dsPIC30F1010/202X Family Silicon Errata and Data Sheet Clarification

The dsPIC30F1010/202X family devices that you have received conform functionally to the current Device Data Sheet (DS70178C), except for the anomalies described in this document.

FIGURE 1:

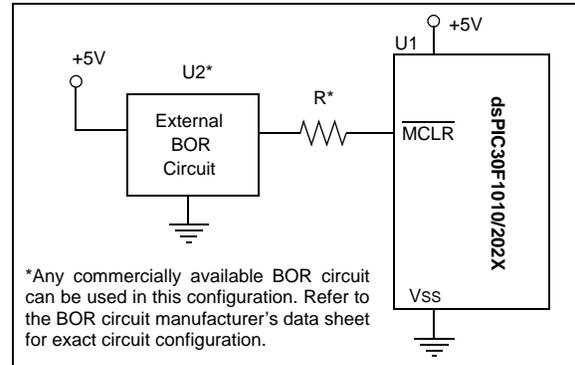
A brown-out event occurs when VDD drops below the minimum operating voltage for the device but not all the way down to VSS. If the dsPIC DSC SMPS device is running with the PLL enabled and a brown-out event occurs, the device may stop running; and, the MCLR pin will not reset the device. When this occurs, the device can only be reset by cycling power to the VDD pins.

The dsPIC DSC SMPS device must be powered up with the PLL disabled, the Fail-Safe Clock Monitor enabled, and Clock Switching enabled. The PLL should be enabled in software via a clock switch after the device is reset (refer to **Section 29. "Oscillator"** (DS70268) in the "dsPIC30F Family Reference Manual" for details on clock switching). This ensures that the MCLR pin is functional and that the device can be reset by an external BOR circuit (see Figure 1).

FIGURE 2: ADDITION OF 100 OHMS RESISTOR ON EXTREF PIN

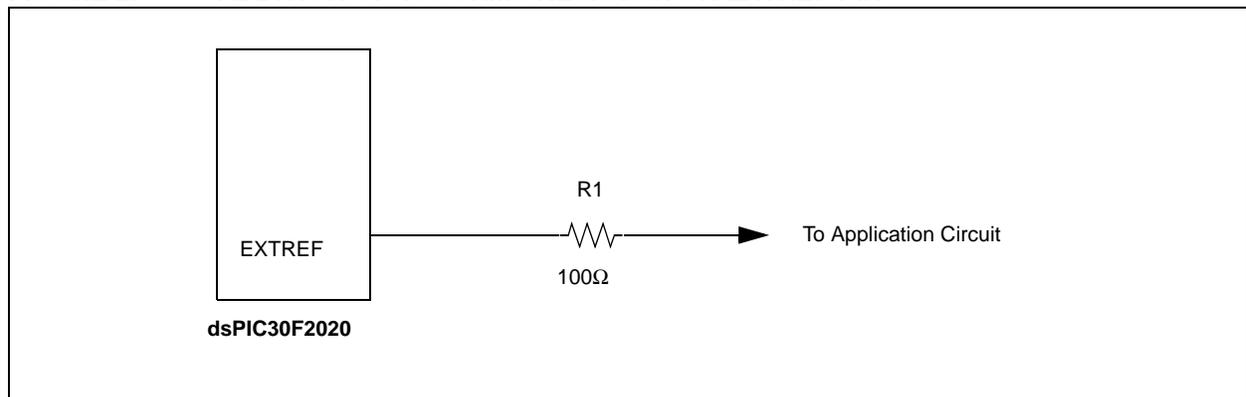
If the EXTREF pin is used in any of the configurations shown in Table 6, it is recommended that a 100 ohms 1/8W resistor be added in series with the EXTREF pin (see Figure 2).

The addition of the 100 ohms resistor effectively makes the EXTREF pin as robust as the other pins on the device with respect to tolerating voltage and current transients. In most of the configurations shown in Table 6, the 100 ohms resistor will have little effect on the operation of the pin. An exception to this is when the pin is configured as the comparator reference, EXTREF. Adding a resistor in series with the reference voltage will cause a slight offset in the gain of the comparator DAC. This gain offset is related to the voltage drop across the 100 ohms resistor.
